Application for Licence Amendment

Licence Number	L8457/2010/2
Licence Holder	Silver Lake (Integra) Pty Limited
ACN	093 278 436
File Number	2012/006865
Premises	Salt Creek Processing Facility Mount Monger Road EMU FLAT WA 6431 Legal description – Mining tenements M25/71, M25/125, M25/133, M25/307, M25/347 General purpose lease L25/27, L25/31, L25/33, L25/41 Miscellaneous licence G25/02 As defined by the Premises maps attached to the Revised Licence
Date of Report	07 November 2023
Decision	Revised licence granted

Figure 4: Comparison of water inputted into TSF2 and return water

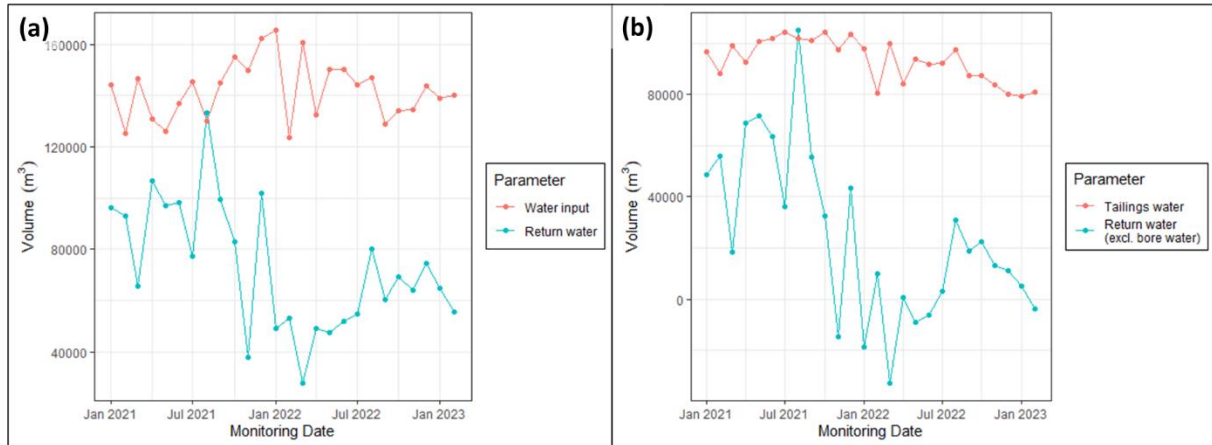
In evaluating the TSF2 monthly water balance in greater detail, the monthly proportion of water inputted (i.e., from tailings slurry and bore water) that was reclaimed from the supernatant pond as return water varied from 17% to 103% (Figure 4a). In 2021, the average proportion of water reclaimed was 65%. However, the average proportion of water reclaimed in 2022 was significantly lower at 40%.

Furthermore, in 2022, the water removed from TSF2 via return water pumping was roughly comparable with the volume of bore water inputted into TSF2 (Figure 4b). In some months, the volume of bore water added exceeded the volume of return water recovered. After accounting for bore water addition, only a proportion of tailings slurry supernatant was removed from TSF2, with over 50% tailings water reclaimed in most months in 2021 (Figure 4b). However, the volume of tailings slurry supernatant removed was significantly lower in 2022.

In summary, although the addition of bore water was required to achieve return water pumping rates, after accounting for this addition, the volume of return water pumped from TSF2 was significantly less than the volume of water inputted into TSF2 as tailings slurry (Figure 4b). The residual tailings supernatant that is not removed from TSF2 via return water pumping represent potential seepage that could be released into the environment. In addition to seepage, tailings supernatant could typically also be lost through evaporation on the TSF surface or retained within the tailings matrix as pore water.

In the water balance provided, the department noted that a pan evaporation factors of 0.5 and 0.88 was utilised for the supernatant pond and tailings beach, respectively. However, the rate of evaporation from the surface of a hypersaline water body is typically lower than for a similar freshwater body. Measurements taken from TSFs with hypersaline water in the Goldfields region have indicated pan evaporation factors of about 0.4 and 0.2 for supernatant pond and

Using the current methodology of deriving seepage volumes, there is limited value in the water balance. The methodology of seepage estimation in the water balance should be revised to produce more realistic outputs, using the ‘input minus output’ approach and a lower pan evaporation factor.

Figure 6: Standing water level trends at groundwater monitoring bores (a) east of TSF2, (b) west of TSF2 (pre-TSF2) and (c) west of TSF2 (recently installed to monitor TSF2)

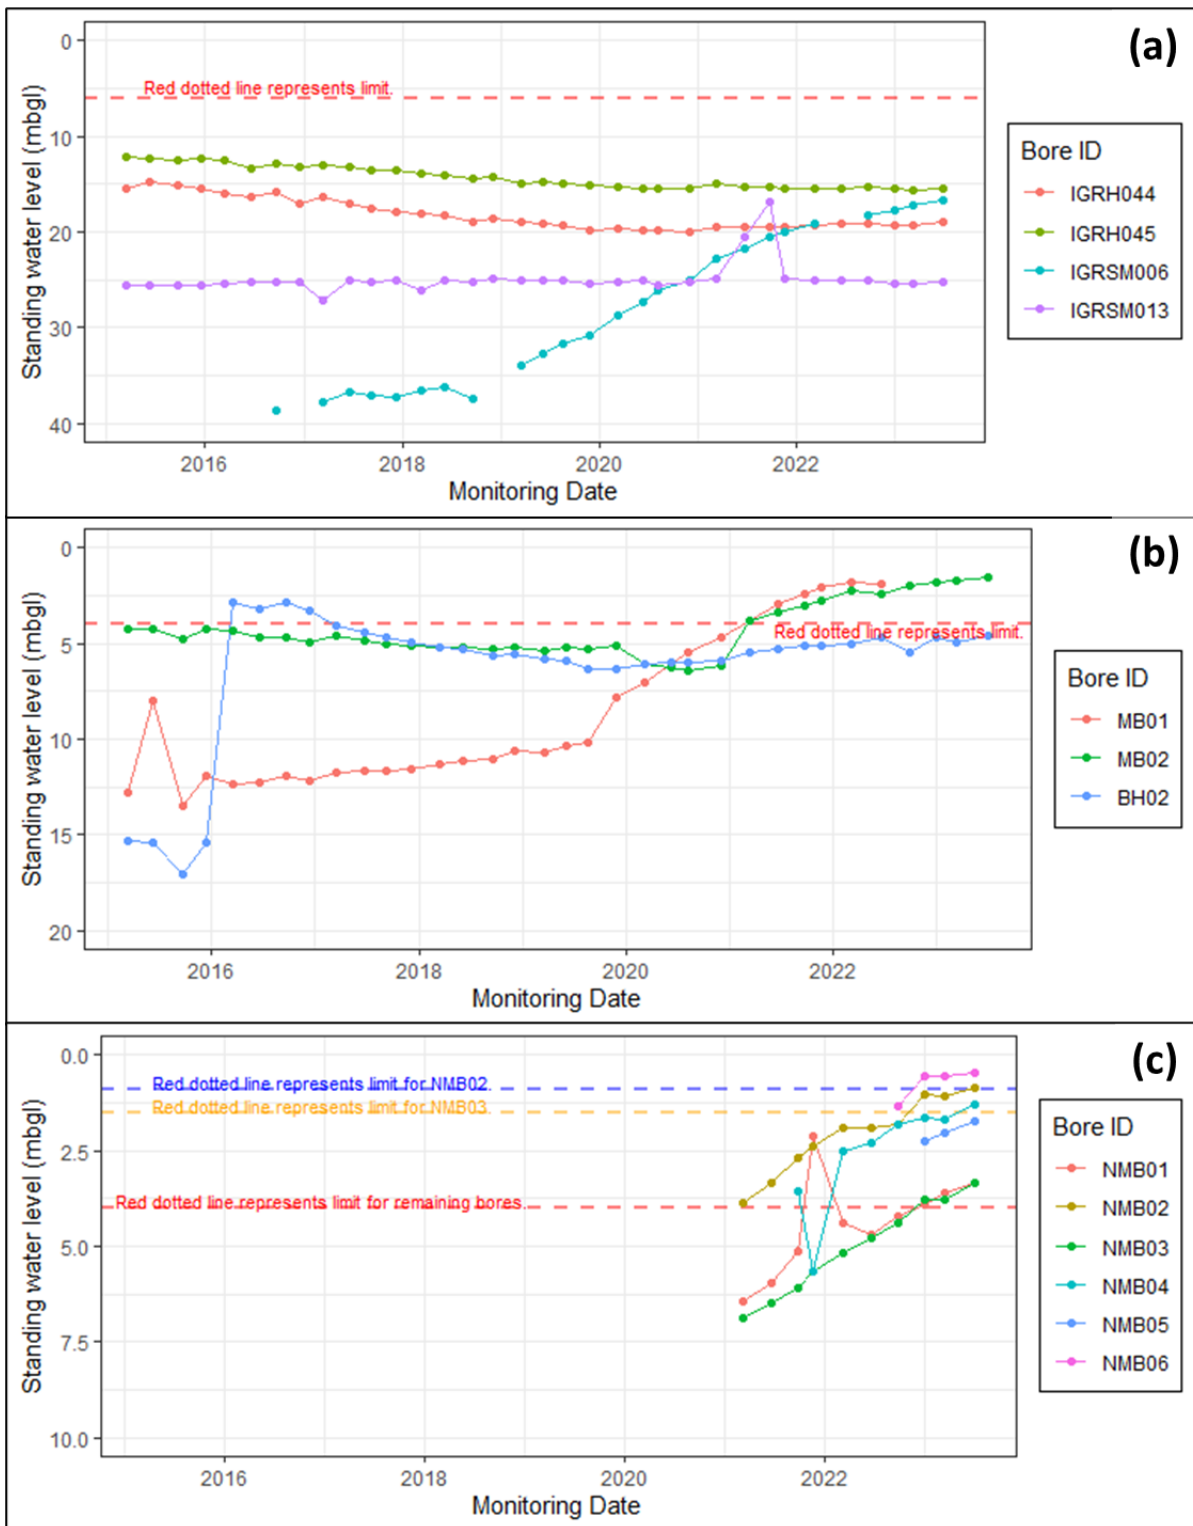
By December 2022, standing water levels at all monitoring bores³ surrounding the western portion of TSF2 were detected above 4.0 mbgl (Figure 6b and Figure 6c). Groundwater was

closest to the surface along the north-west and south-west of the premises. In March 2023, monitoring bores NMB06 (i.e., north-west) and NMB02 (i.e., west) had standing water levels at 0.47 mbgl and 0.86 mbgl, respectively. Contouring of groundwater elevation data from this monitoring event indicated that the local water table was present between RL 292.0 m and RL 296.0 m⁴, flowing in primarily a south-westerly direction (Figure 7).

Figure 8: Weak acid dissociable cyanide concentrations

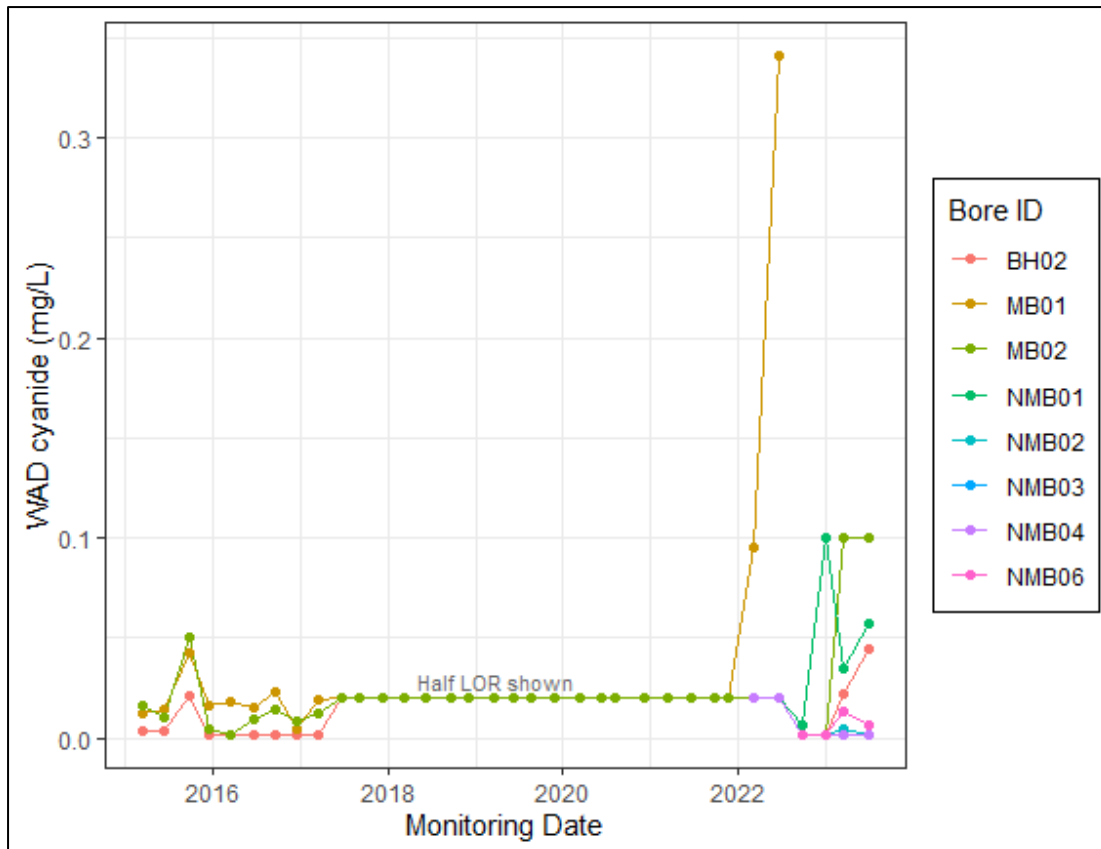
Since 2017, WAD CN has historically been detected below the limit of reporting. However, detectable concentrations of WAD CN have been observed in monitoring bores BH02, MB002, NMB02 and NMB06 during groundwater monitoring events in 2023 (Figure 8). Earlier, in 2022, WAD CN was also detected in monitoring bores NMB01 and MB001.

Despite the lack of temporal trends observed in the existing groundwater monitoring data, the recent detection of WAD CN in groundwater monitoring bores may be indicative of seepage from TSF2. That being said, seepage influences on the aquifer may have occurred long before WAD CN was detected in groundwater samples as cyanide may be bound up in metal-complexes that is not detected in WAD CN analytical procedures. Additionally, WAD CN can be rapidly degraded by subsurface microorganisms in some geological environments, resulting in a short half-life.

Figure 9: Groundwater chemistry plots at monitoring bore MB001 and replacement bore NMB06

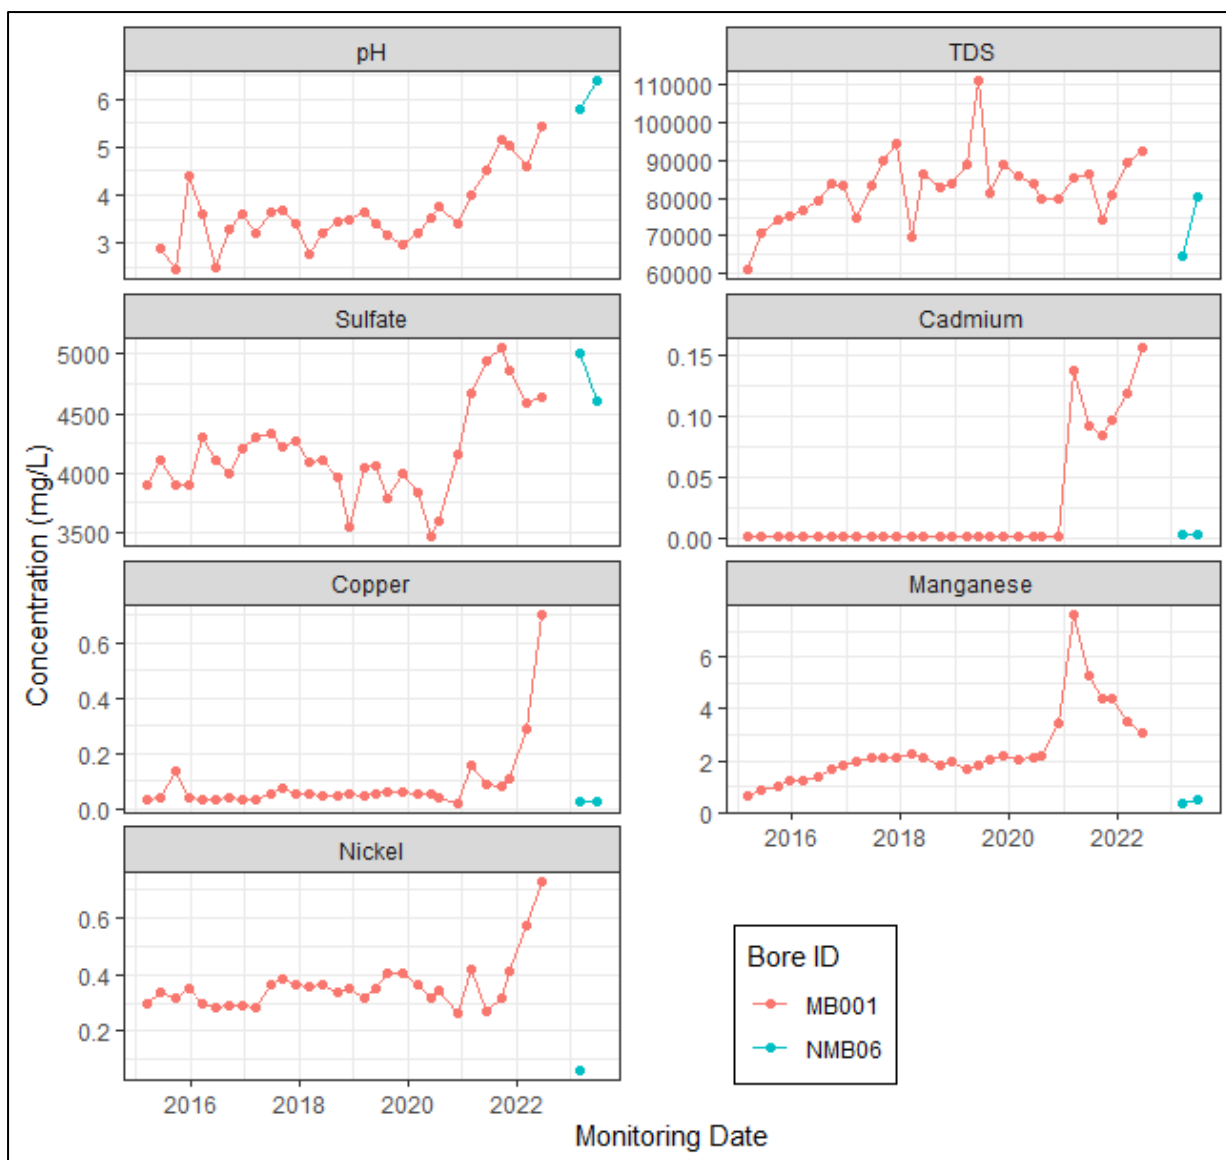
A monitoring bore of potential concern was the now-decommissioned MB001 located north-west of TSF2, which had reported the shallowest groundwater, not only has the standing water level at this bore location increase logarithmically since 2019 (Figure 6) and WAD CN concentrations up to 0.34 mg/L in 2022 (Figure 8), changes in the groundwater chemistry had also been observed (Figure 9). Specifically, field pH appeared to have increased from historically around 3 pH units to 5 pH units in the 2021 monitoring events onward. In addition, dissolved metal concentrations of copper, nickel, manganese and cadmium, as well as sulfate concentrations also became elevated during this period. Heavy metals, such as copper and nickel, are known to form strong complexes with cyanide ions and are readily leached from minerals during gold ore processing (Rees & van Deventer 1999). No significant changes in TDS were observed. No further monitoring is possible at this location as the monitoring bore was decommissioned in 2022 to construct the North Groundwater Recovery Drain.

A shallower replacement monitoring bore NMB06 was installed in September 2022 approximately 35 m away from MB001. Groundwater sampled at this monitoring bore was less acidic, with sulfate concentrations comparable to MB001 (Figure 9). Of note was that elevated metal concentrations previously identified in MB001 were not elevated in monitoring bore NMB06, despite being a shallower bore (and thus, able to detect impacts from seepage from immediately). Continued monitoring is required to better understand the groundwater in this area, given previous observations at MB001.
